Access Compliance Report

Public Rights-of-Way

(Pedestrian Signals)

Intersection ID: N/A	Main Street:	Cross Street: N/A	Location: N/A
ADA ID: DF8683A1ABAA	Signal Type: One Push Button-Non APS	Overall Compliance: No	Severity Score: BTN 1: N/A BTN 2: N/A No BTN: N/A
Codes/Mitigation Info/Possible Solution		Field Measurements/Component Compliance

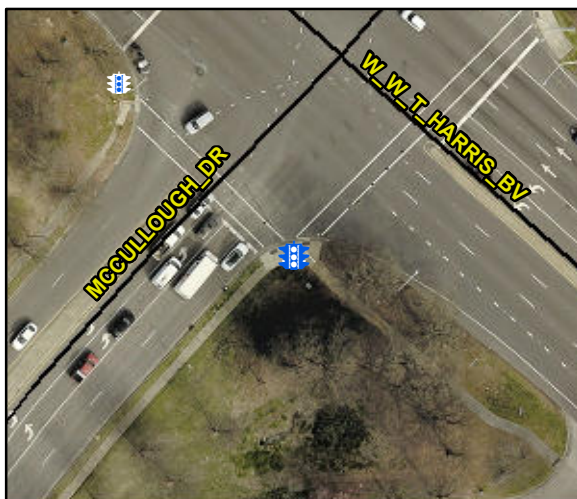
PROW/ADA: TMUTCD 4e.08, R404.2, R404.3, R406.2, R404.7.3, R404.7.2, R104.2, R209.1

Possible Solutions: Replace Signal Push Button With APS Button on New Post. Remove & Relocate Sign.
